Project Title : WALGREENS CLINIC RENOVATION

City of Aurora Plan Review

NO.	DATE	BY	DESCRIPTION	CONST.
1	01-26-09		PERMIT RESPONSE: WALGREENS REVIEW #1

COVER SHEET

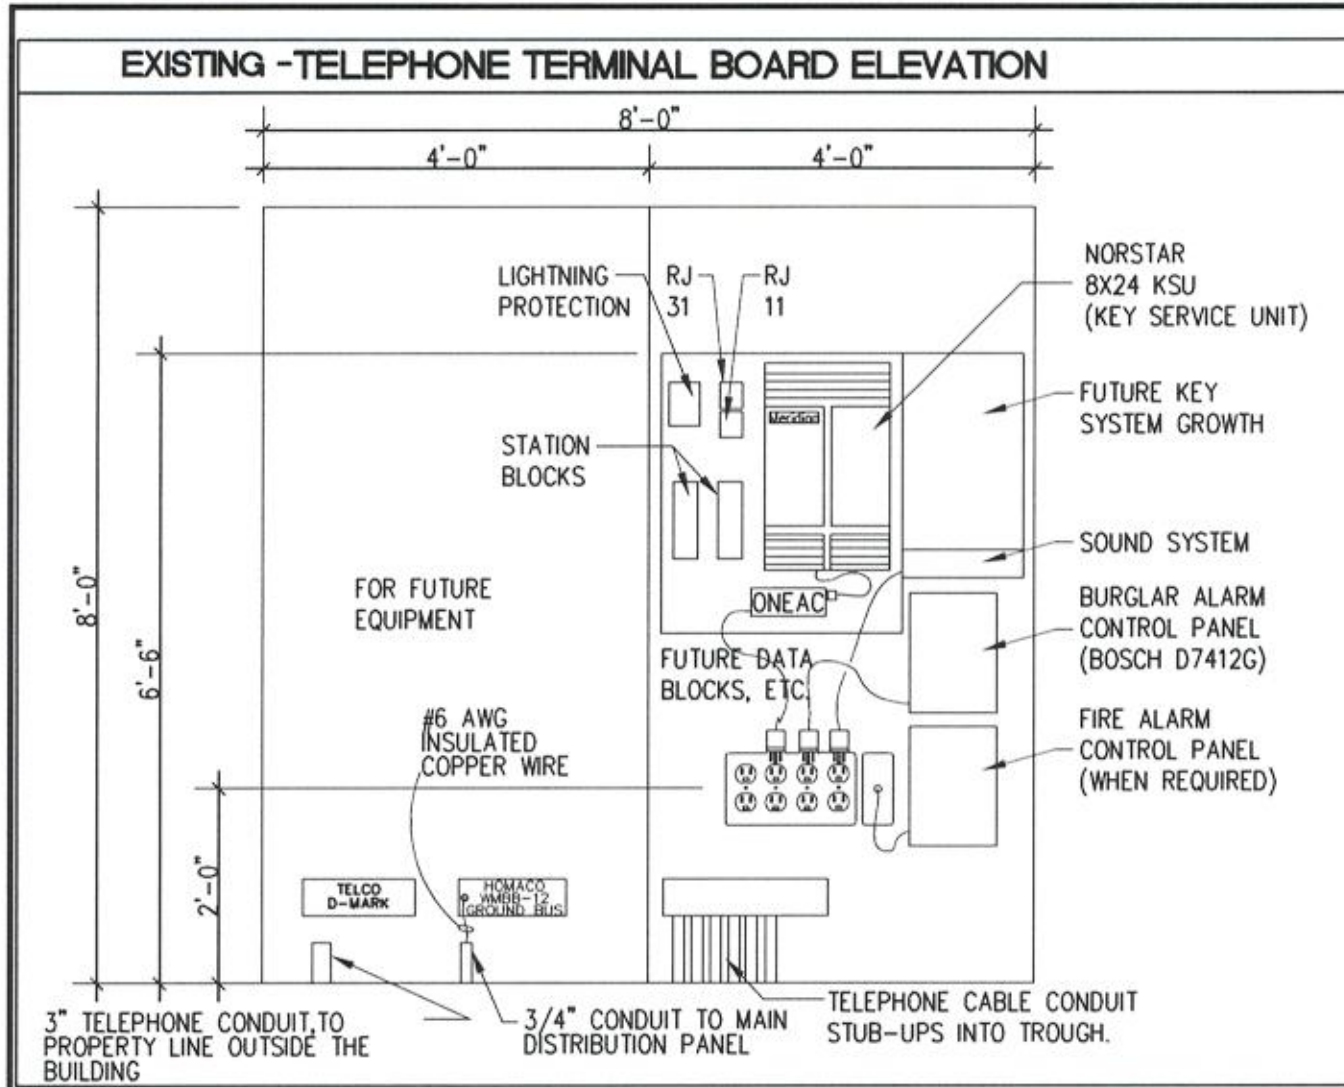
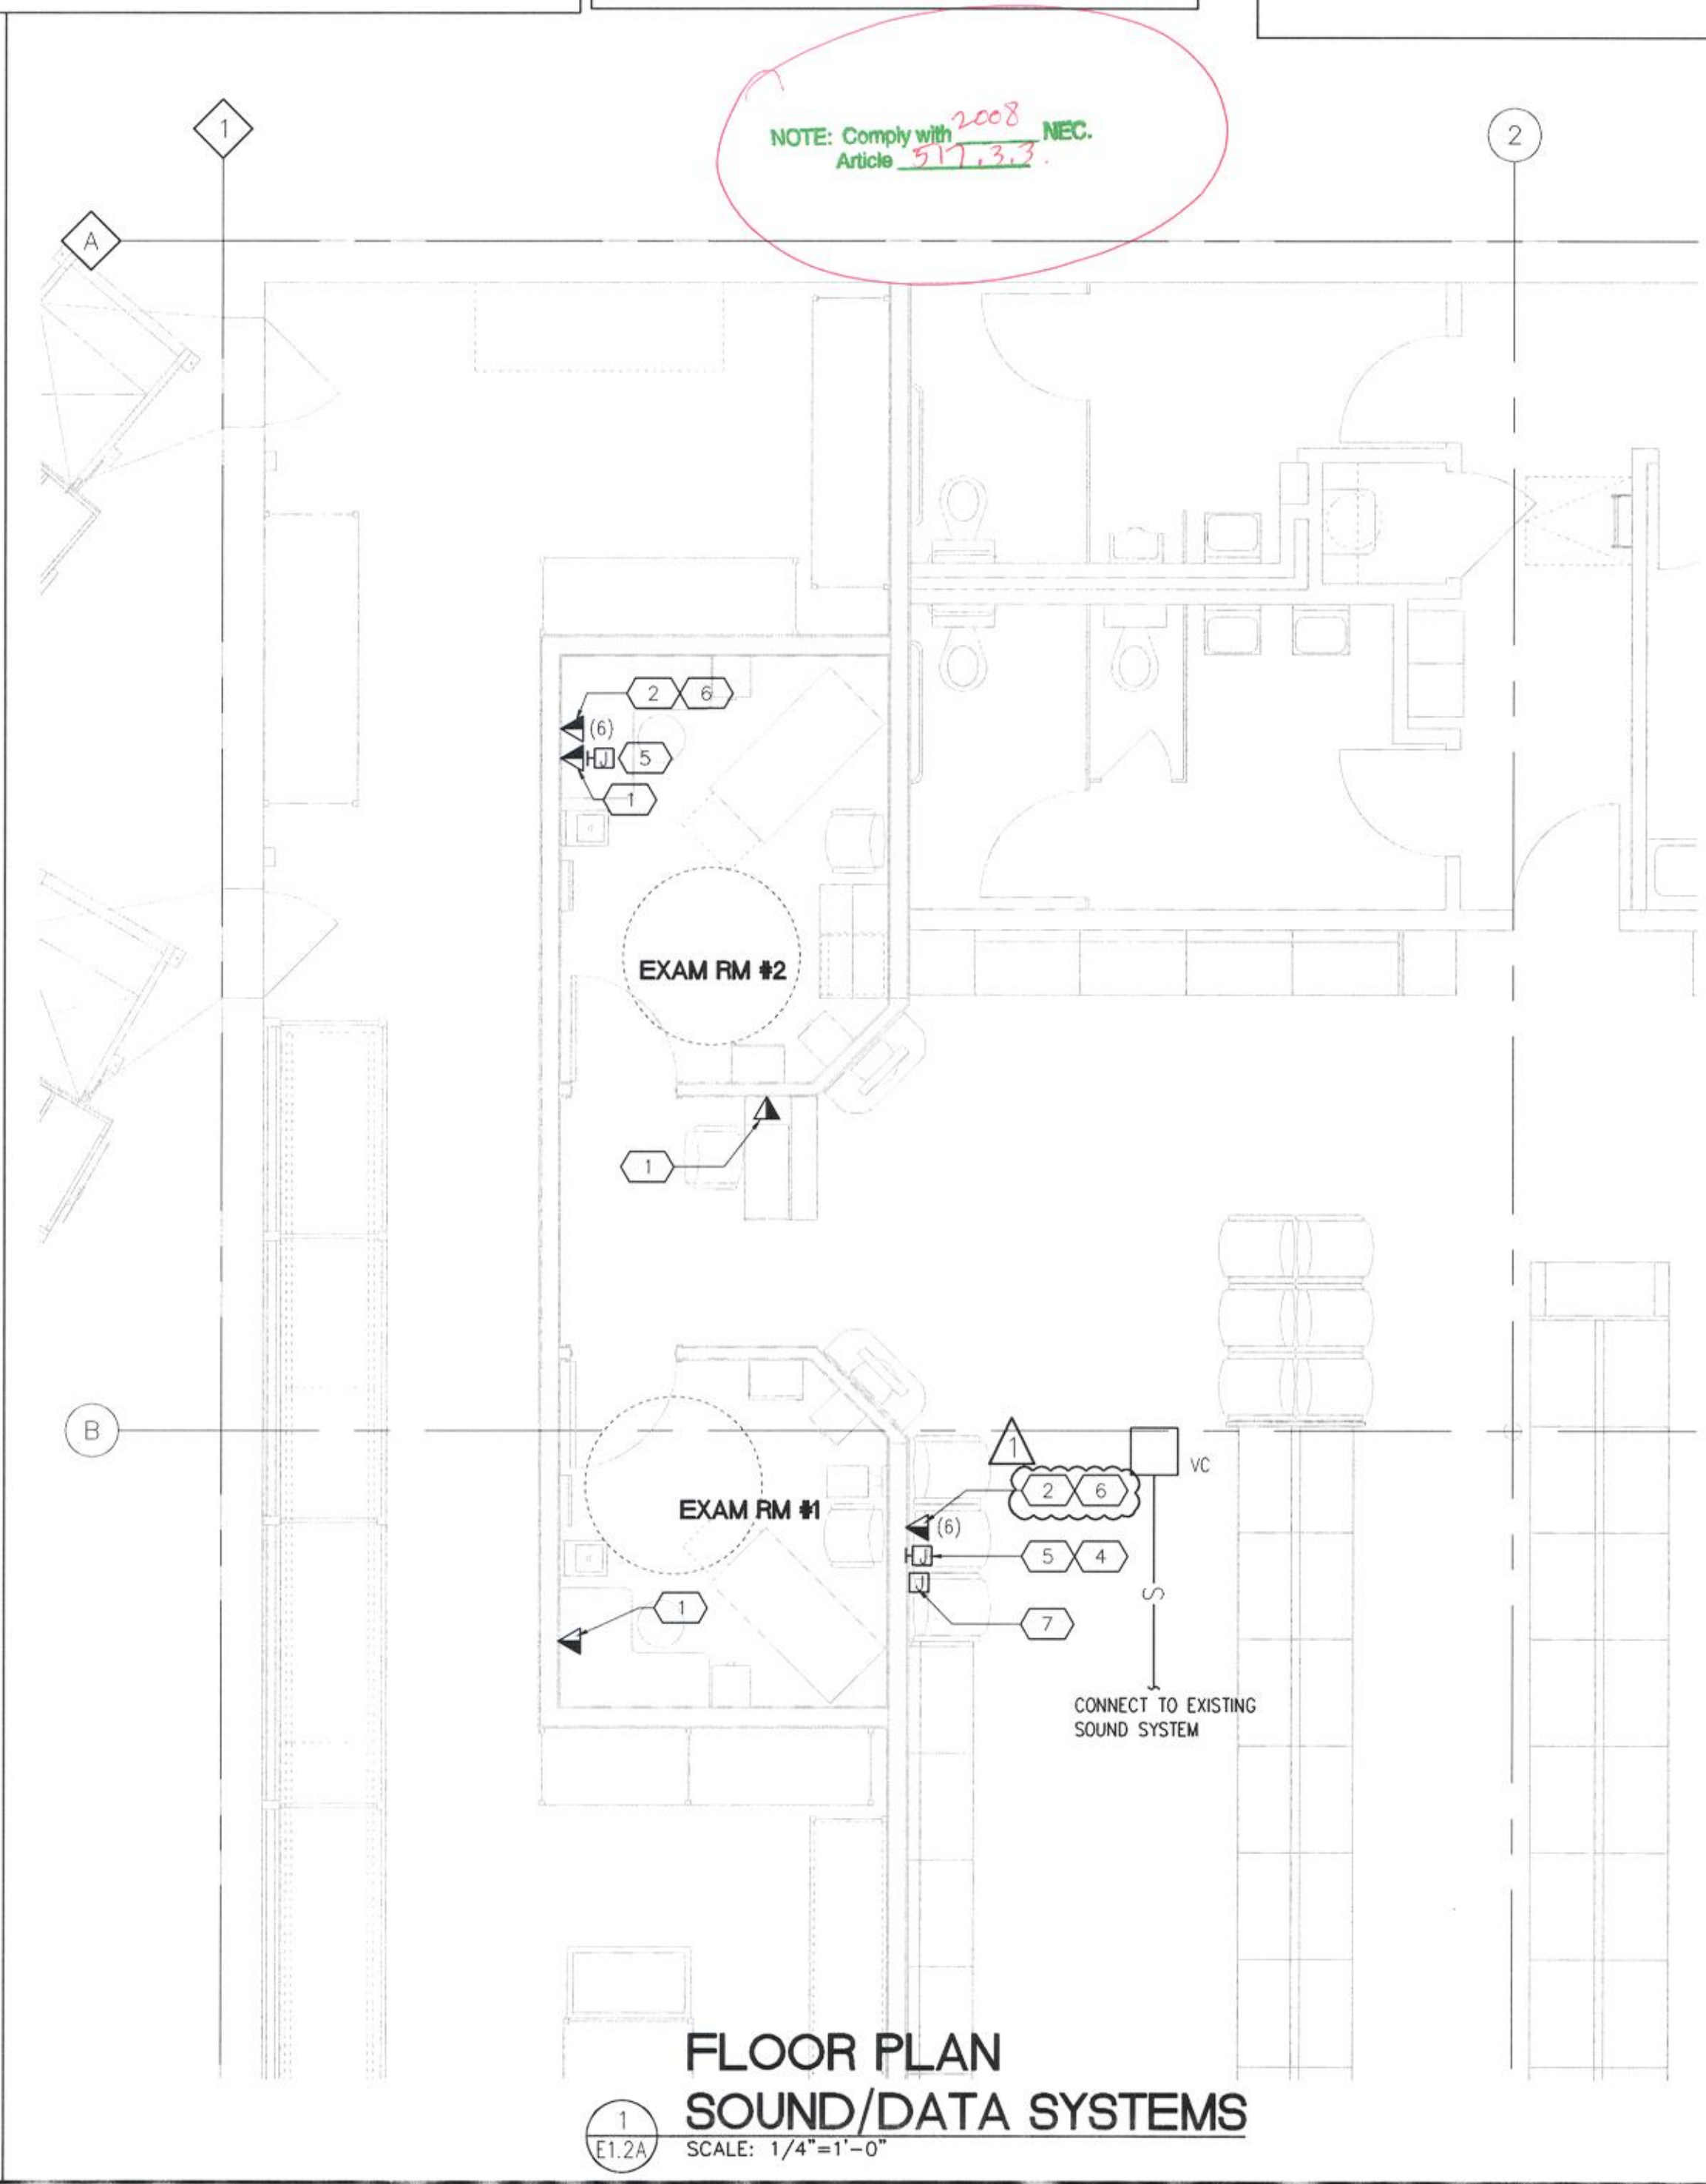
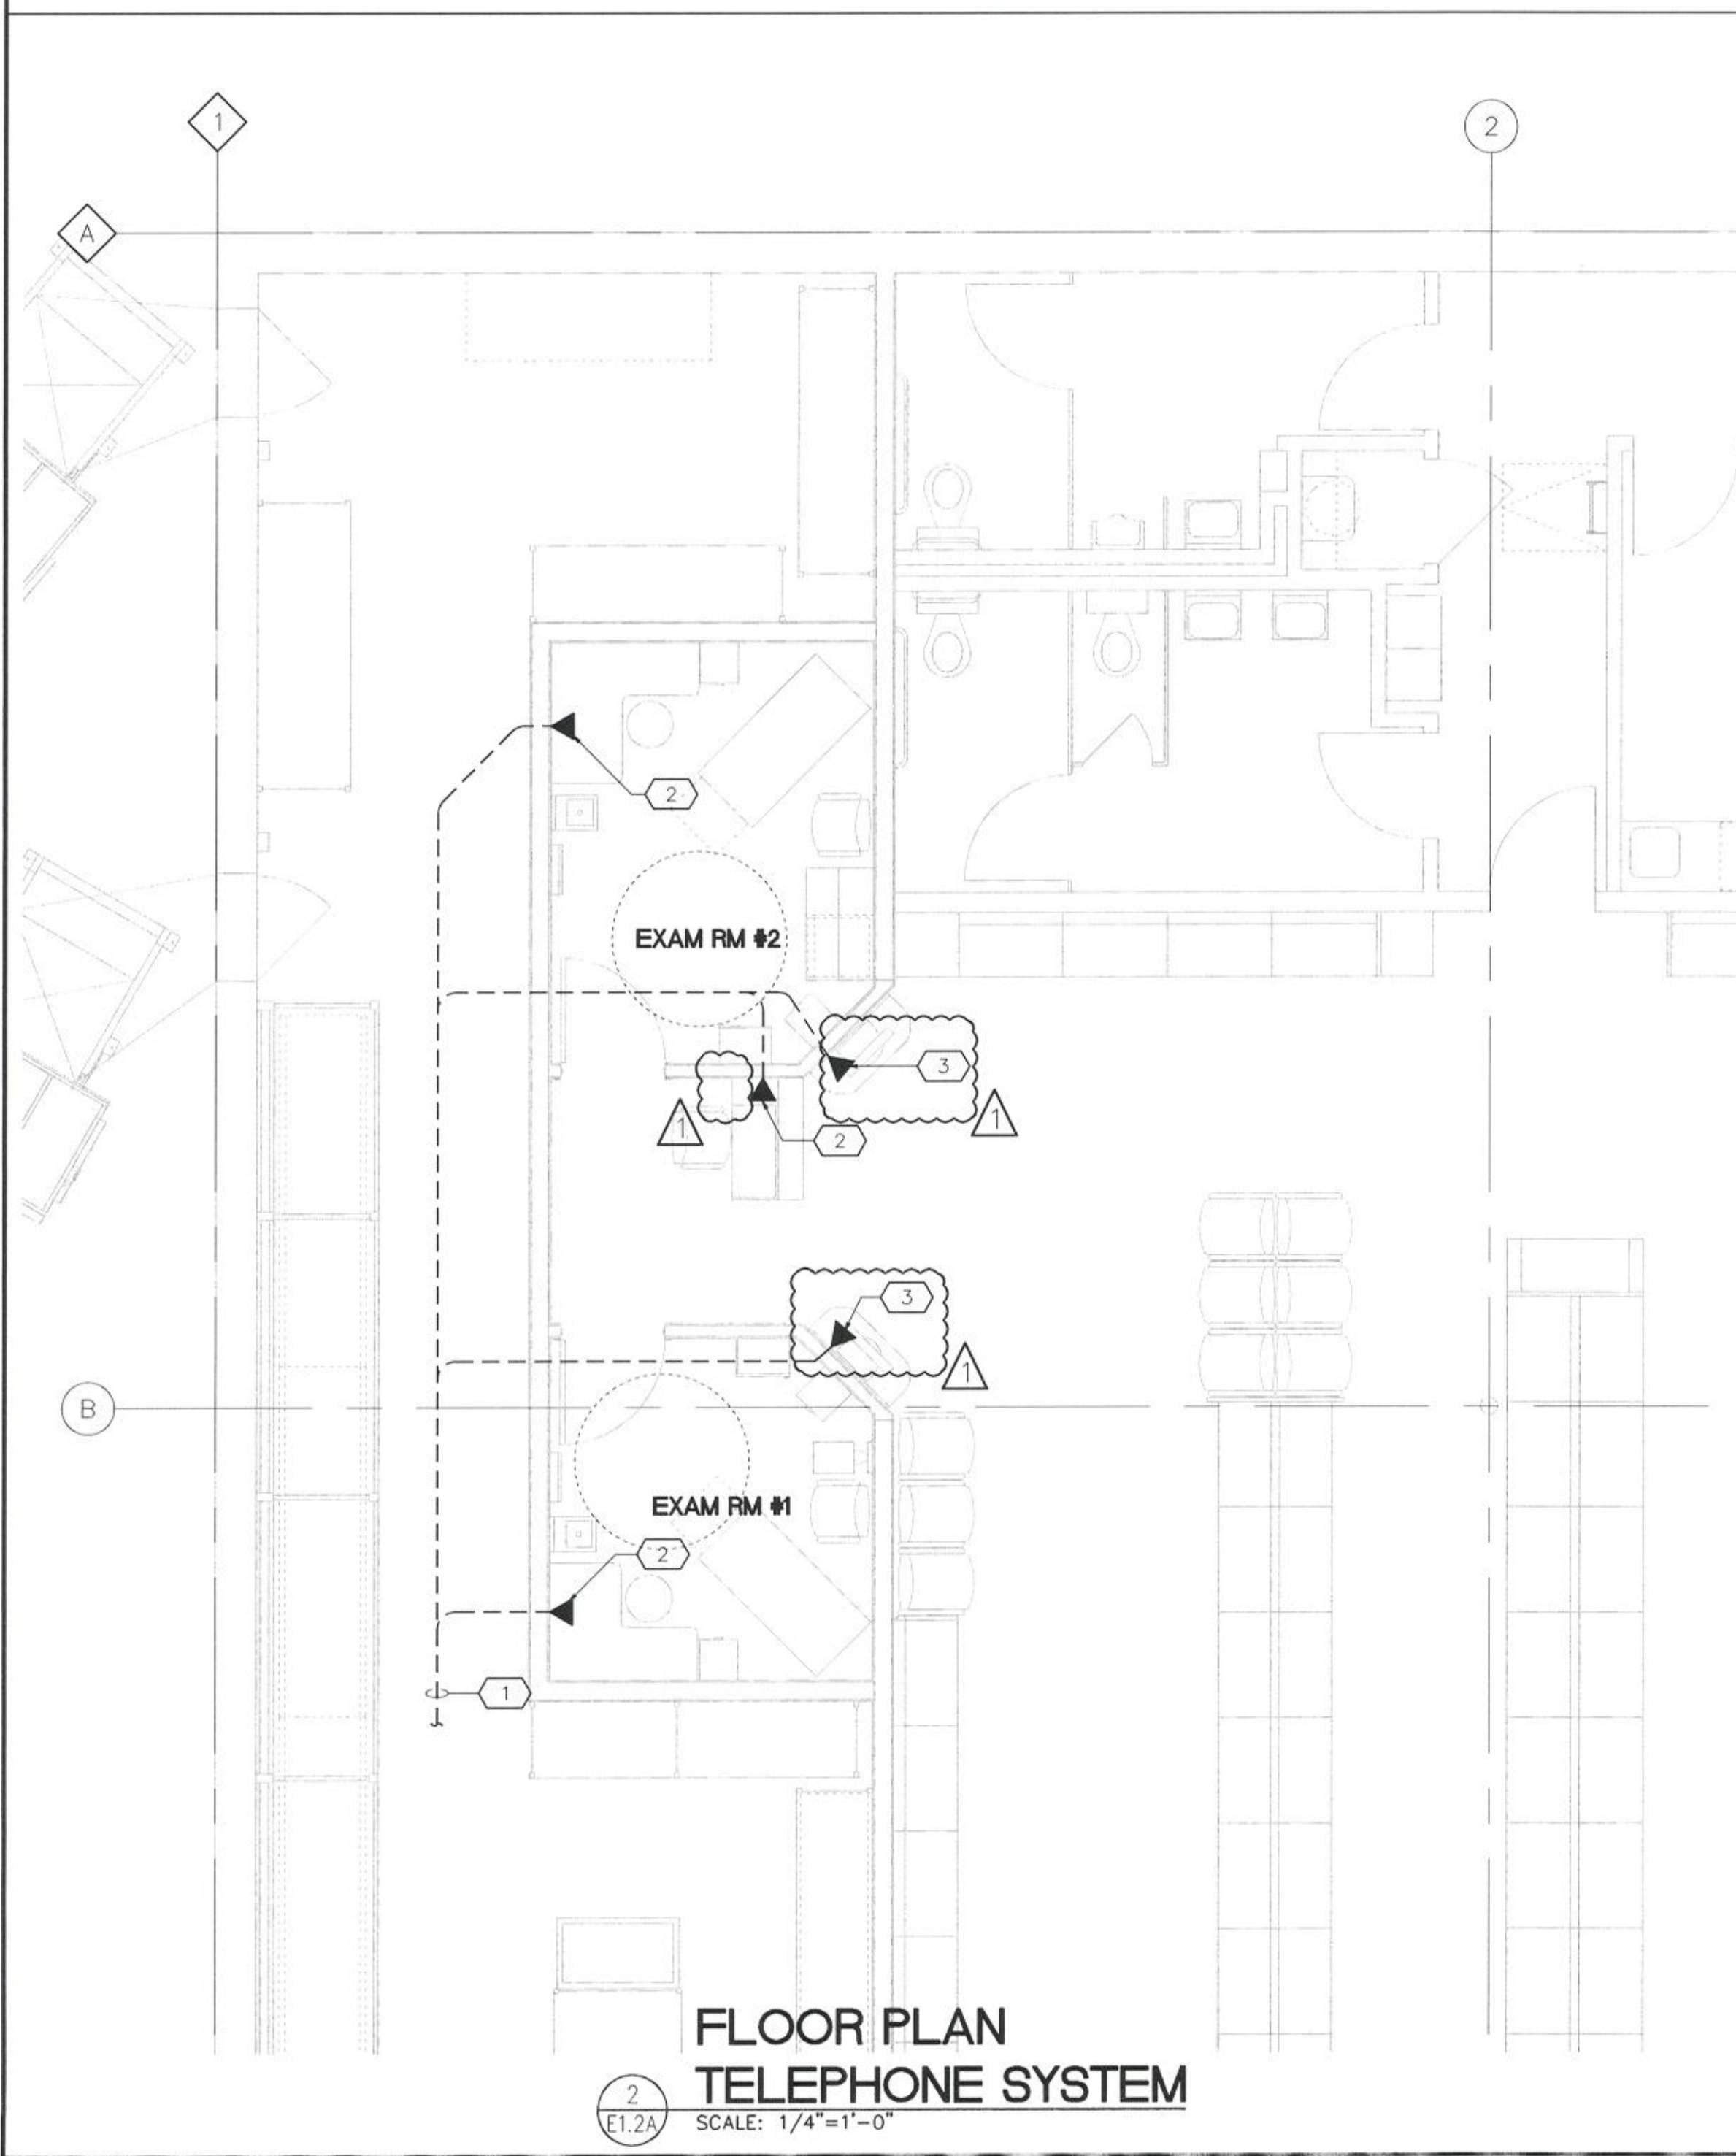
Provide emergency illumination equipment that complies with 2008 NEC 700-12 (F) or 2008 NEC 700.

The rating of all series rated panels shall be marked on the panels. Provide manufacturers information and cut sheets onsite and available during field inspections per 2008 NEC 240.86 (B).
